drawings. Corrected Figures 2, 5, 8 and 10 in which the changes have been indicated in red ink are attached for the Examiner's approval. Corresponding amendments have been made to the specification as well as some editorial corrections. As required by 37 C.F.R. s. 1.121, applicant has provided a separate version of the amended portions of the disclosure, showing the changes relative to the previous versions (attached). An abstract has also been added as required by the Examiner.

VERSION WITH MARKINGS TO SHOW CHANGES MADE

FIG. 5

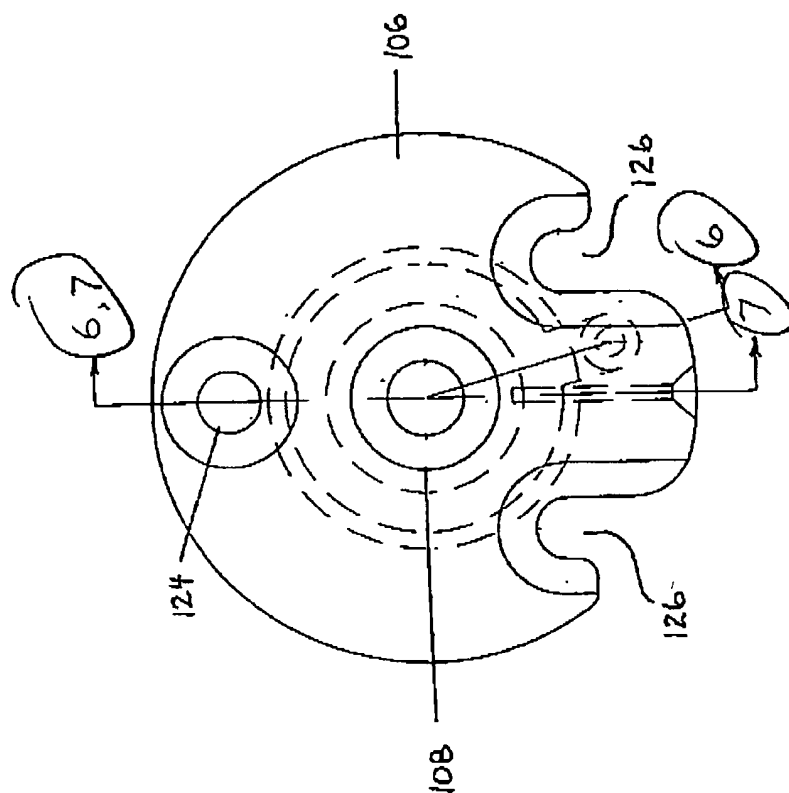
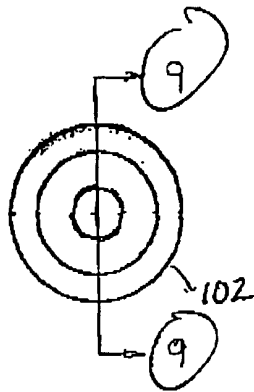
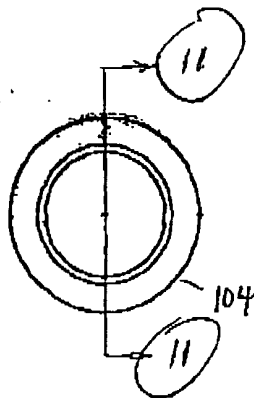
Fig. 6 is a cross-sectional view of the flow control valve shown in Fig. [3] 5 taken along lines [A-B] 6-6;

Fig. 7 is a cross-sectional view of the flow control valve shown in Fig. [3] 5 taken along lines B-B) 7-7;
